Issue 1
16 July 2023

Sterling Denims Ltd. Unit-2

Observations

Figure: Beam reinforcement (in²) in GF Floor of the building

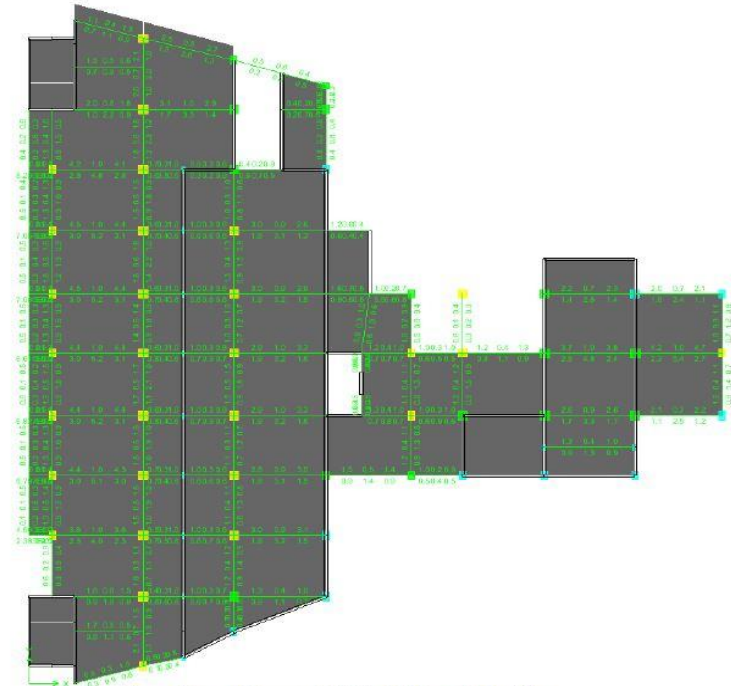
Plan irregularity/diaphragm irregularity/weak storey check/slab design not provided in design report

Plan irregularity/weak storey check not provided in design report. Also, only a brief description for slab is provided rather than providing a detail design of slab. Building engineer is required to update the design report including all requirements of BNBC 1.9.1.

Prepared load plan to be revised

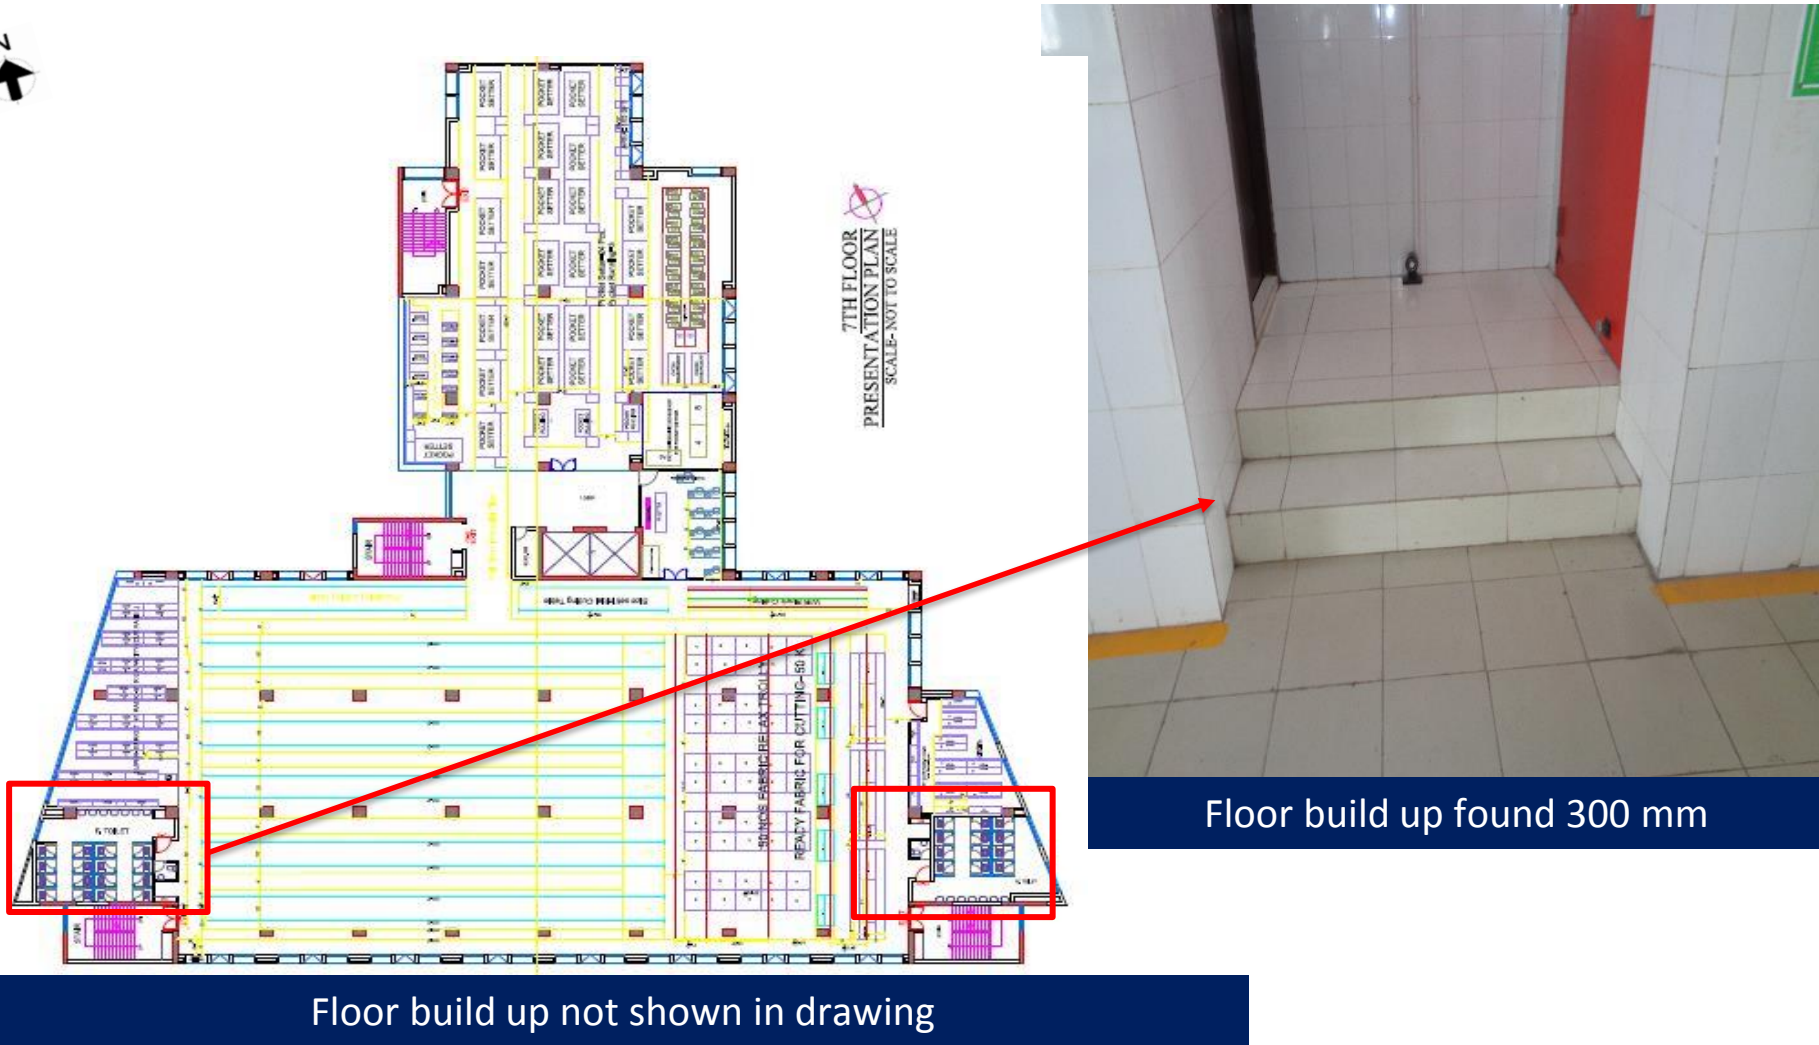
Live load on highlighted area is considered as 5 kPa in prepared load plan. As per BNBC- Part 6, live load for light storage areas is required to be considered minimum 6 kPa. Building engineer is required to revise the load plan as per BNBC requirement and check the design accordingly.

Possible vehicle impact for column

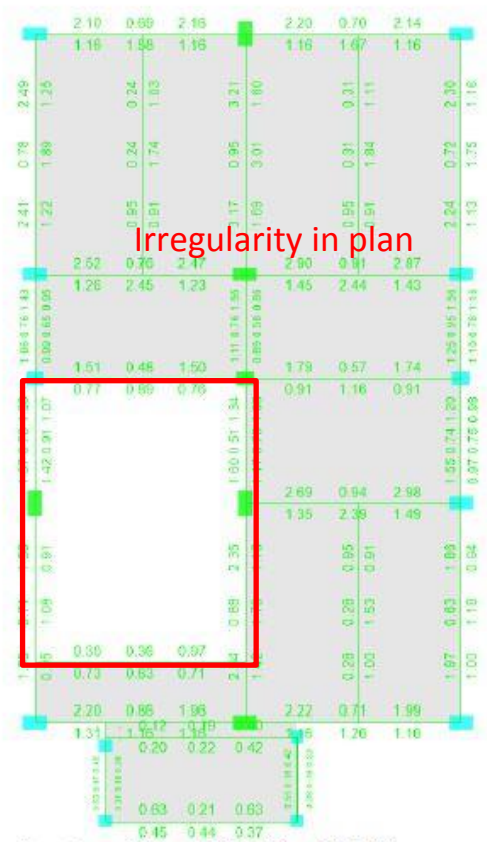
Inadequate safety barrier provided for the exposed columns at ground floor

Columns at ground floor are prone to possible vehicle impact. Building engineer is required to provide barrier for all exposed column at ground floor to prevent from possible vehicle impact.

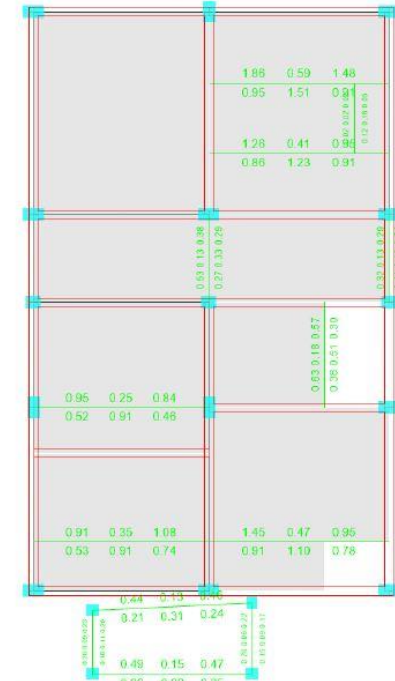
Weak storey/diaphragm irregularity check/slab design not provided in design report

Weak storey check not provided in design report. Also, only a brief description for slab is provided rather than providing a detail design of slab. Building engineer is required to update the design report including all requirements of BNBC 1.9.1.

FEA model for super structure

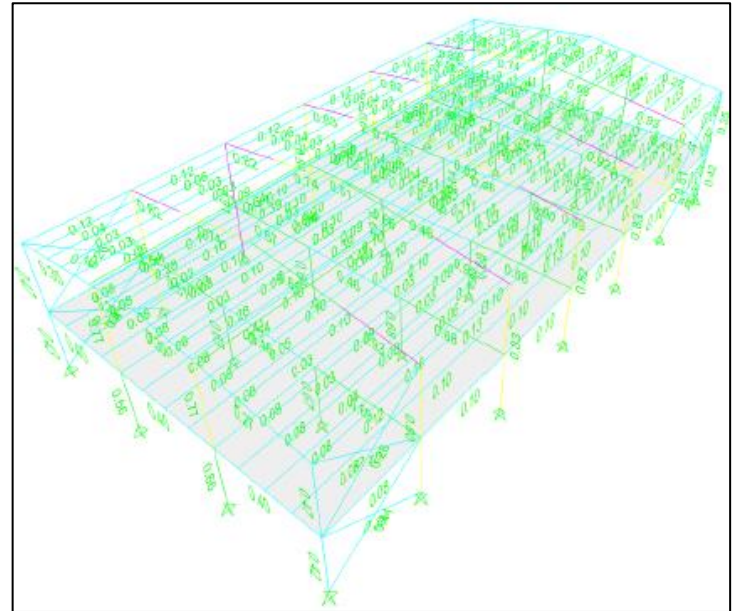
In design report, concrete design strength 3500 psi and steel MS plate design strength 50 ksi has been considered. However, no material test report was available to confirm these considered material strength. In addition, no adequacy check for pedestal column was also provided. Building engineer is required to update the design report including all requirements of BNBC 1.9.1.

Oversized hole in bolted connection

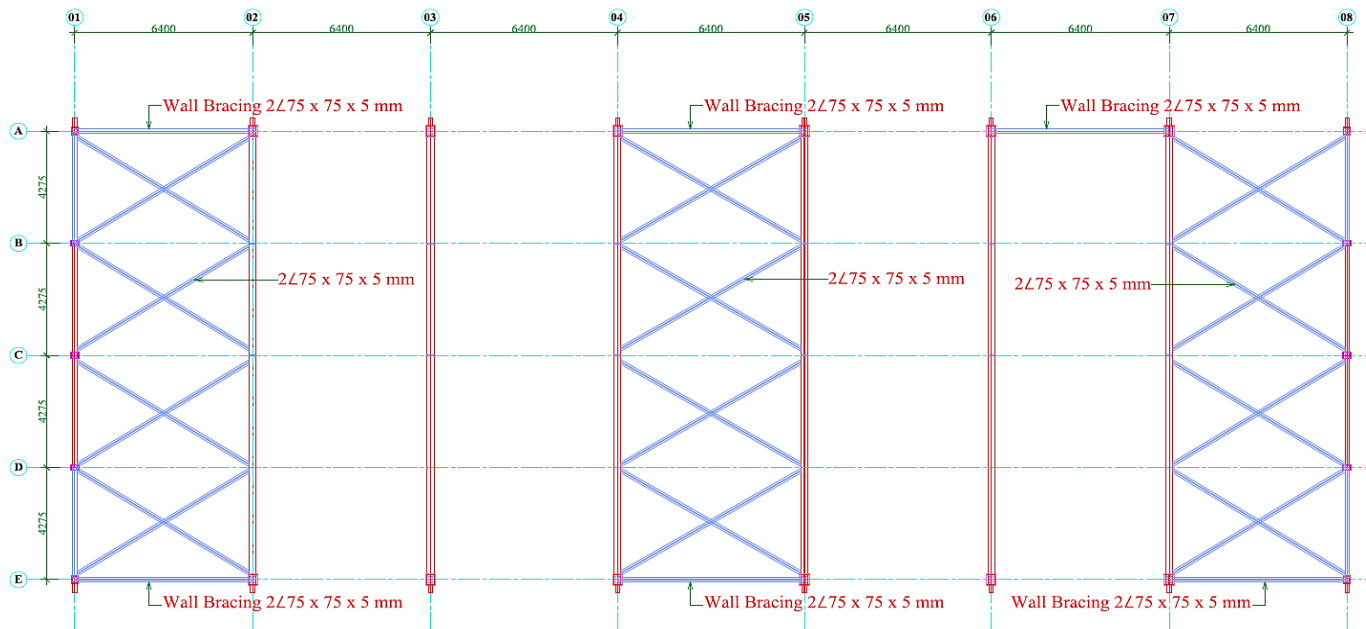
Oversized hole, loose bolt and gap between connection plates observed in bolted connection. Also, the steel bracing connections and the gusset size appeared to be inadequate. The building engineer is required to check the connections adequacy as part of EA and fill up all the connection gaps & tighten the bolt with proper engineered way.

Apparently inadequate bracing gusset plate and eccentricity in joint

Gap between connection plates & loose bolt

Bracing layout drawing: 2L-75x75 mm bracing at roof

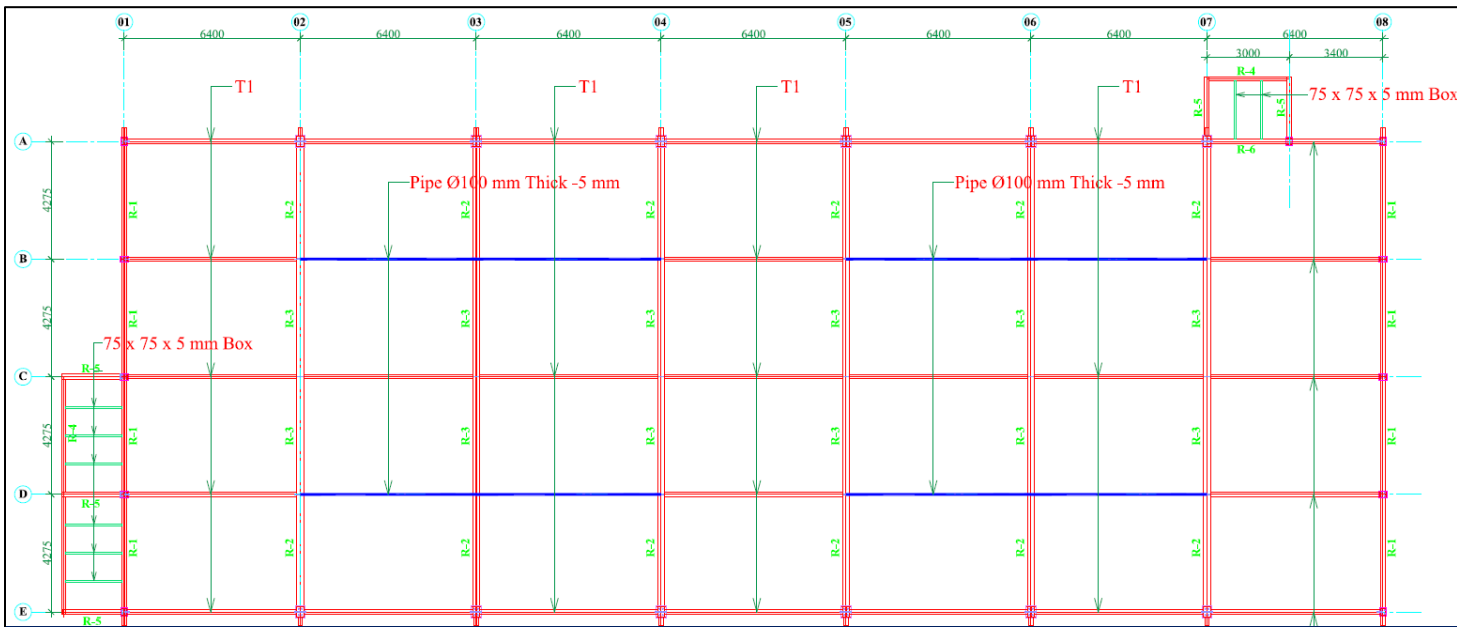
2L-50x50 mm bracing measured at roof

50x50 mm bracing was found instead of 75x75 mm bracing at roof. The building engineer is required to survey the structures and prepare accurate as-built drawings with connection details. Also, check the adequacy of the shed for the actual size of bracing members.

Cantilever rafter of Canopy-01

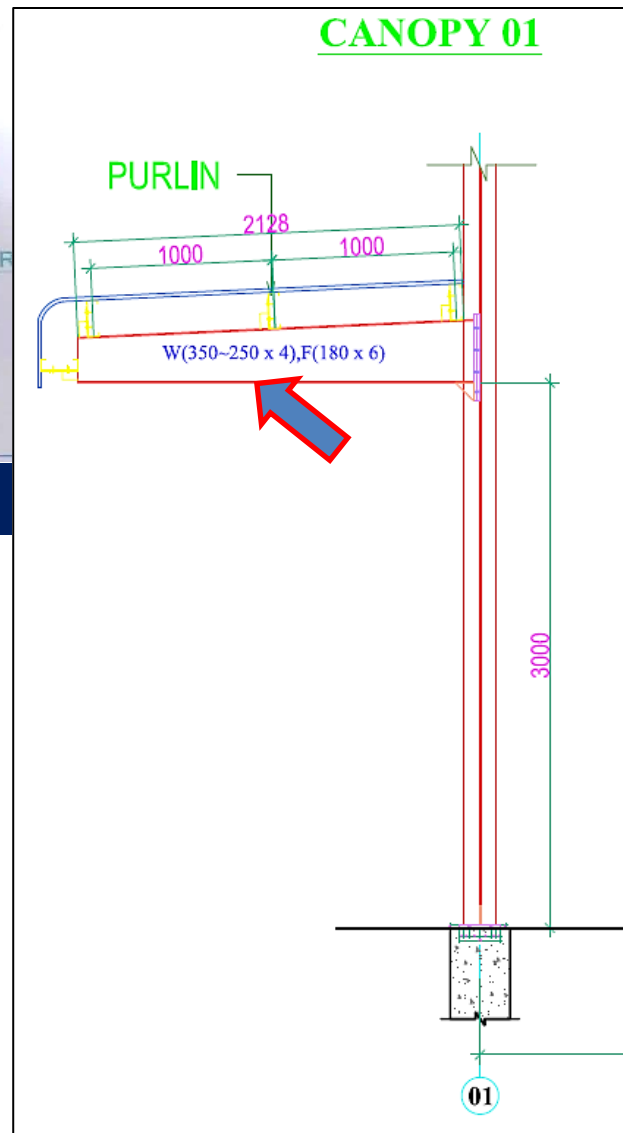
Cantilever size- W350~250x4,F180x6

Cantilever size- W250~125x4,F150x6
measured onsite

Mismatch found between cantilever rafter sizes. The building engineer is required to survey the structures and prepare accurate as-built drawings with connection details. Also, check the adequacy of the shed for the actual size of rafter members.

Crack in brick walls

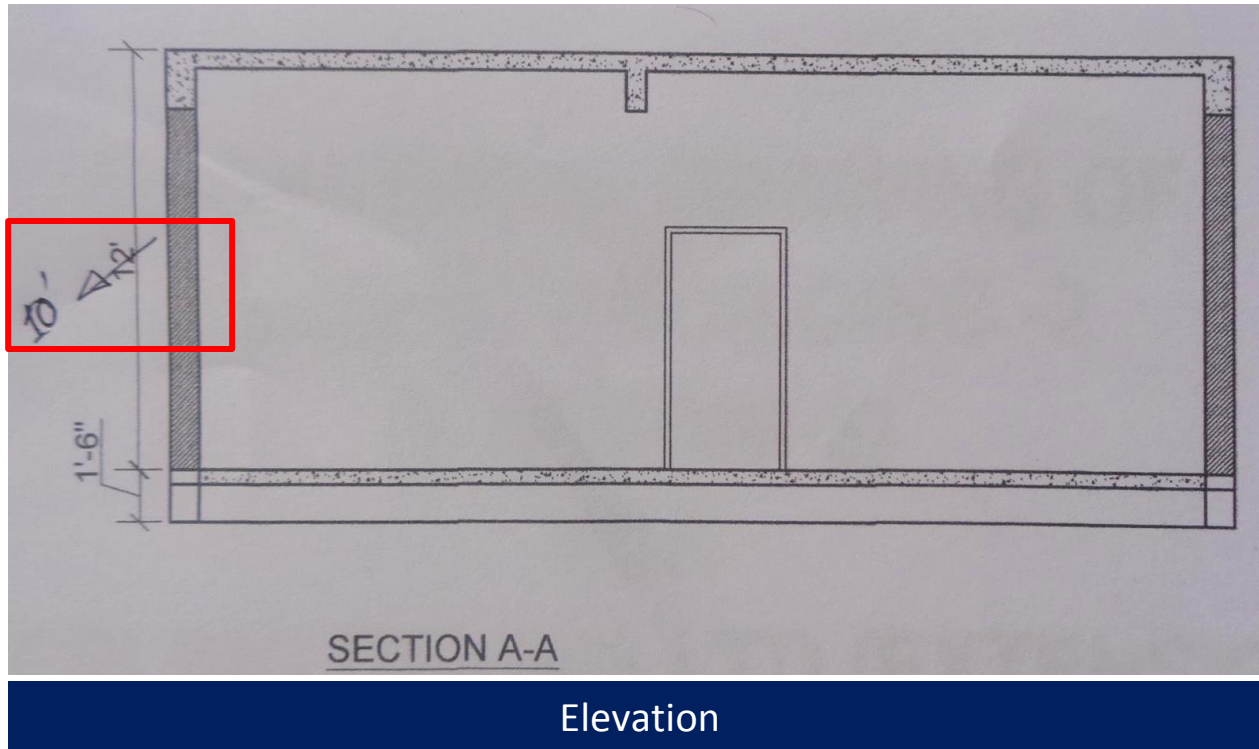
Crack observed in brick walls. The building engineer is required to identify the reason of crack and carry out suitable remedial works.
